BREEZY POINTE 2ND ADDITION

Re: S/D 92-44 BREEZY POINTE 2ND ADDITION (FINAL PLAT)

STAFF REPORT
(Final Plat Approved 10/1/92)

CASE NUMBER: S/D 92-44 - BREEZY POINTE 2ND ADDITION

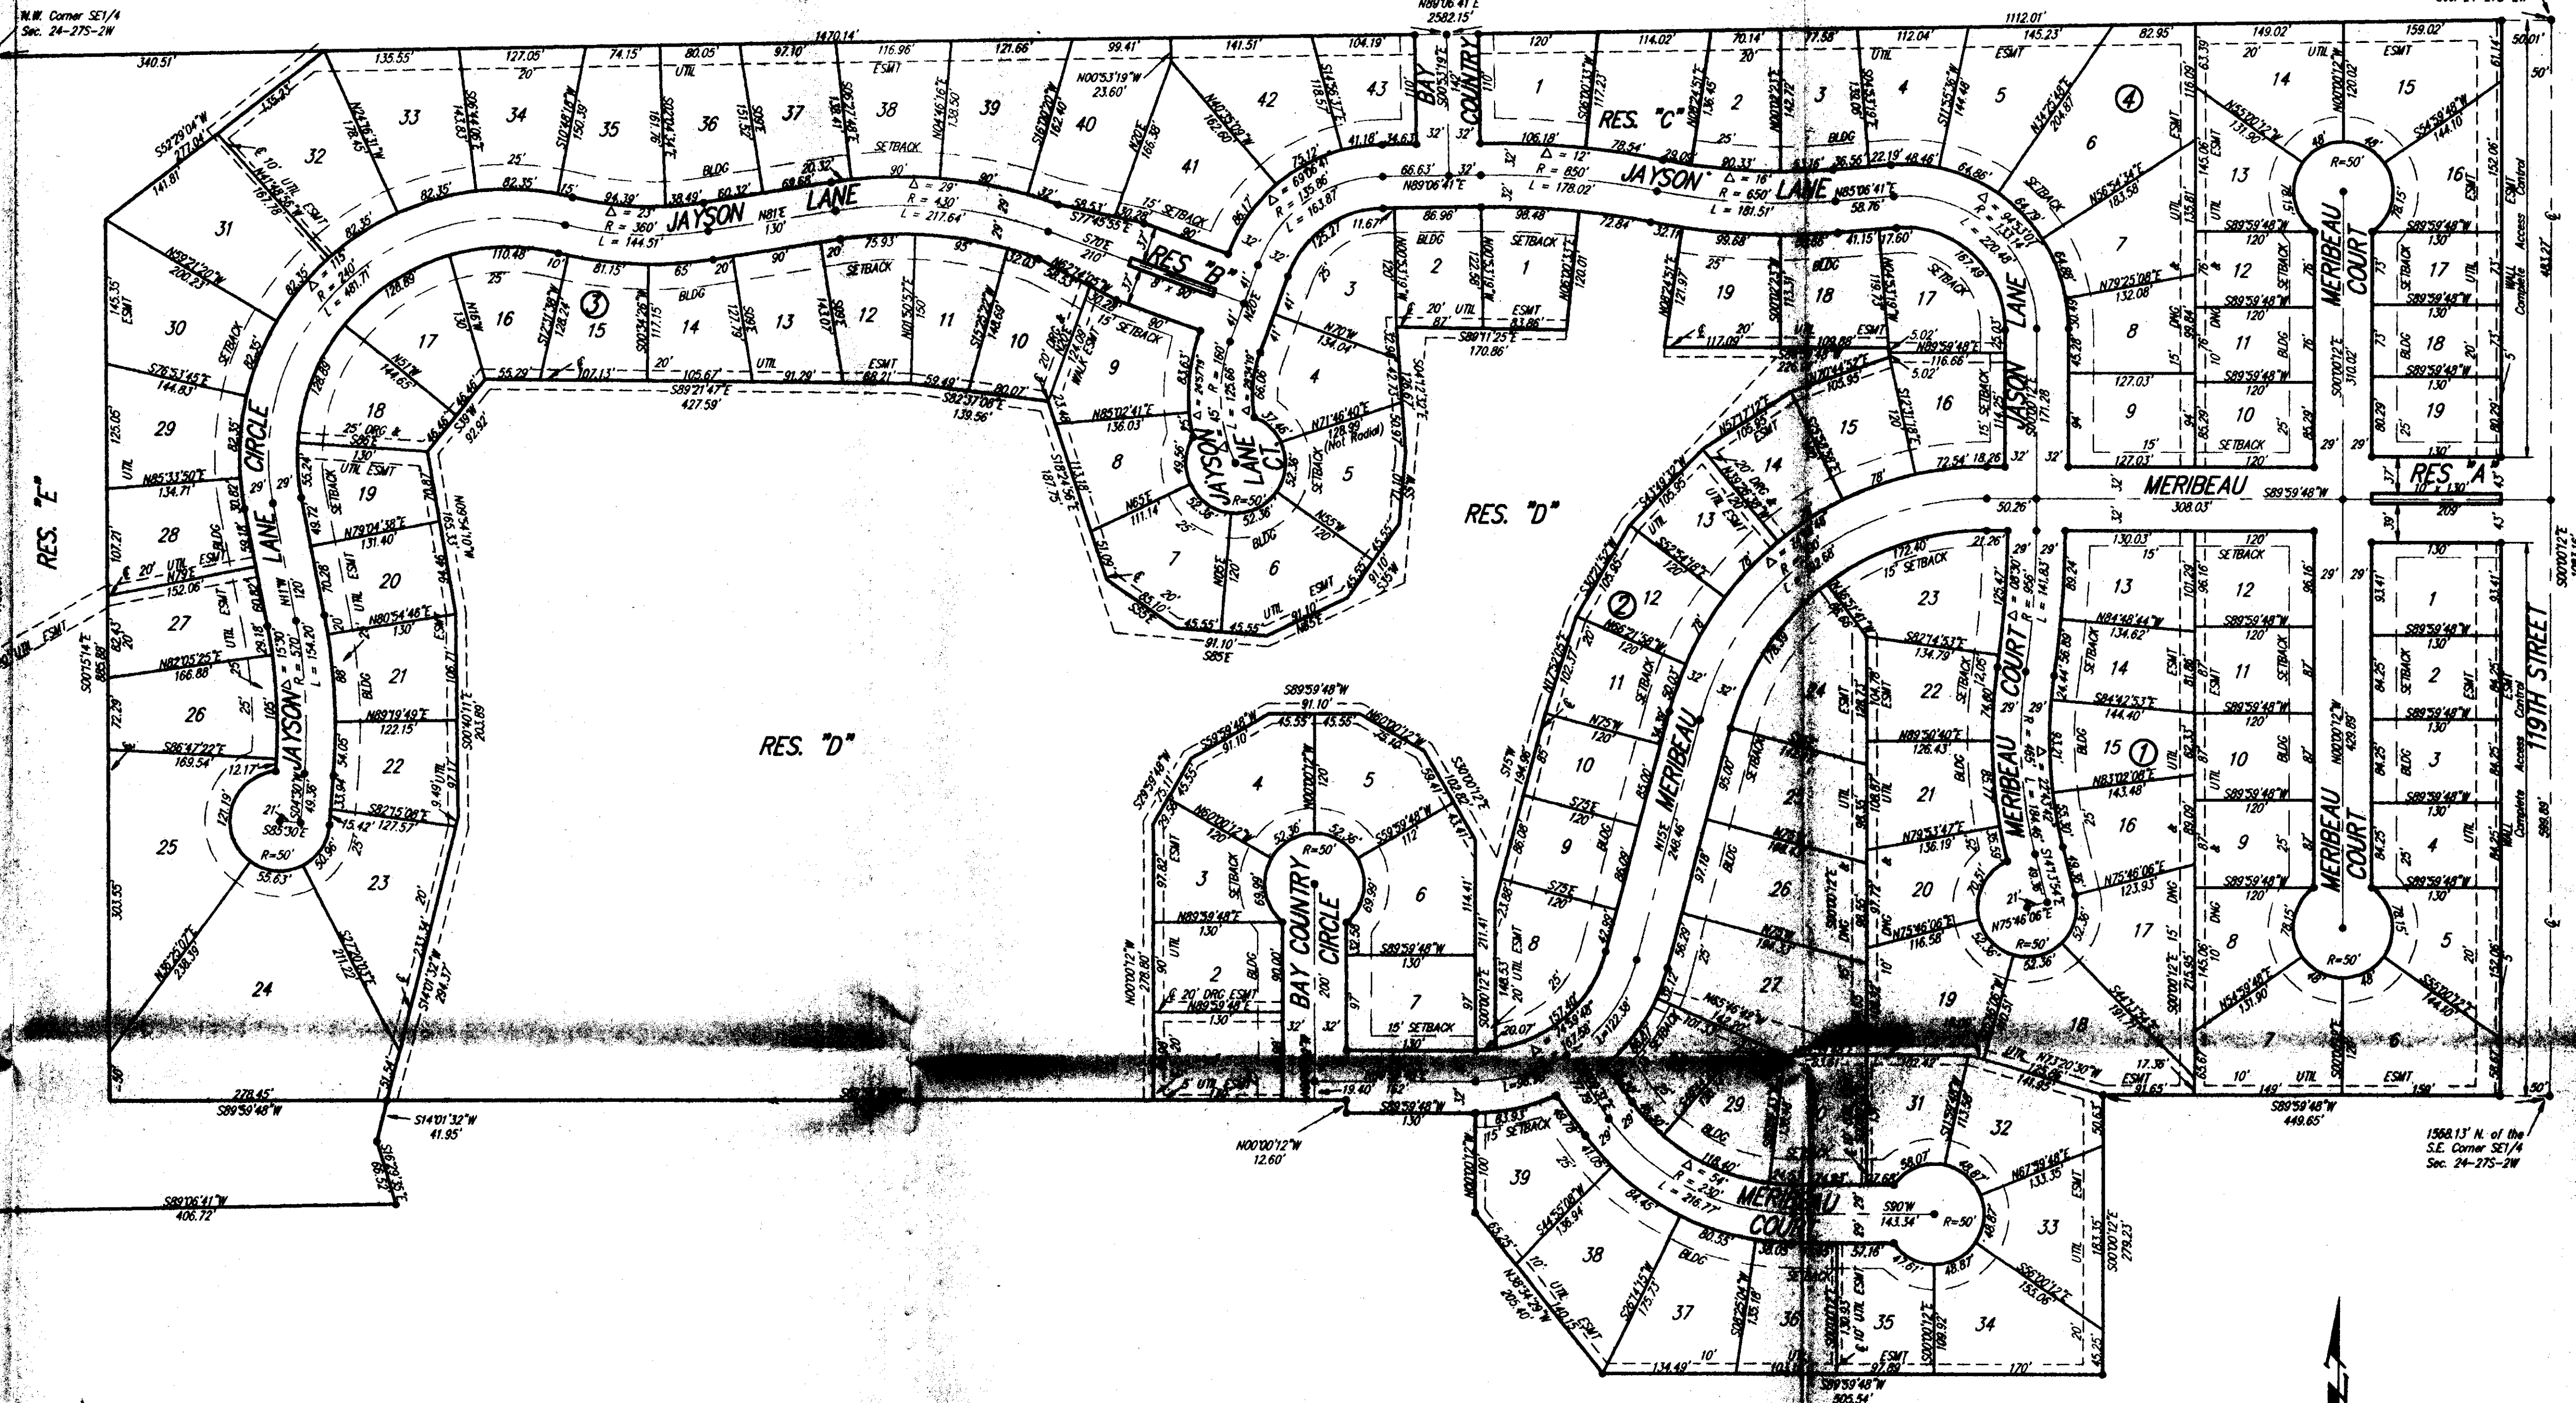
- T. As was noted by the representatives from K.G. & E. and Southwestern Bell, additional easements are required on the revised final plat. The final plat tracing shall indicate any such required easements and the applicant shall submit letters from these utilities indicating that all needed easements have been provided.

- W. The final plat tracing shall indicate that the minimum pad elevations are for the lowest floor level, unless verification is submitted to City Engineering from FEMA, indicating that any involved lots are not within a regulated floodplain.

- A. The applicant shall guarantee the extension of sanitary sewer to serve the lots being platted.
- B. The applicant shall guarantee the extension of City water to serve the lots being platted.

- C. The applicant shall guarantee any drainage improvements required by the platting of this property.
- D. The applicant shall guarantee construction of the storm sewers required by this plat.

- E. The applicant shall guarantee the paving of the proposed interior streets.
- F. As requested by Traffic Engineering, the applicant shall guarantee a left turn lane in 119th St. North to serve this site. This improvement will be held until such time as 119th St. West is widened.

- G. The applicant shall guarantee the installation of sidewalk in this addition to correspond to the system of sidewalks found or planned in the additions north and south of this site. Specifically, sidewalk needs to be guaranteed along one side of Meribeau from 119th Street West to Bay Country Court as shown at the south line of the plat. Also, sidewalk needs to be extended along Cedar Park/Jayson (as shown on this plat) from Meribeau to where Bay Country enters this site from the north.

It is recommended that because of the extensive length of Jayson-Breezy Point Circle that sidewalk be continued along this street segment from Bay Country to the end of the cul-de-sac.

- H. If improvements are guaranteed by petition, a notarized certificate listing the petitions shall be submitted to the Planning Department for recording.
- I. Both in terms of length and the number of dwellings accessing Breezy Pointe Circle/Jayson, this street requires platting at the 64-foot right-of-way standard. The amount of traffic that enters and consequently must exit past the same lots would be expected to exceed reasonable traffic volumes for a street allowing potentially only one moving lane. Further, this excessively long cul-de-sac will be largely surrounded by Reserves used for drainage purposes and no reasonable alternative means of emergency access can be provided except along this street.

Under such conditions, the Subdivision Regulations have indicated that a 64-foot right-of-way is to be provided. The final plat tracing shall plat this street to the 64-foot right-of-way standard.

- M. The applicant shall submit a covenant which provides for four (4) off-street parking spaces per dwelling unit on each lot which abuts a 58-foot street. The covenant shall inventory the affected lots by lot and block number and shall state that the covenant runs with the land and is binding on future owners and assigns.

- N. Access for residents into Reserve D appears to be extremely limited, especially for the properties along the north and west sides of Block 3. It is recommended that an additional means of access such as the extension of the reserve or an access easement, be provided somewhere in the area of Lots 10 to 24 of Block 3.

- O. A typographical error in the platting text should be corrected where reference is made to the uses of reserves for drainage purposes (instead of drainage purposed).
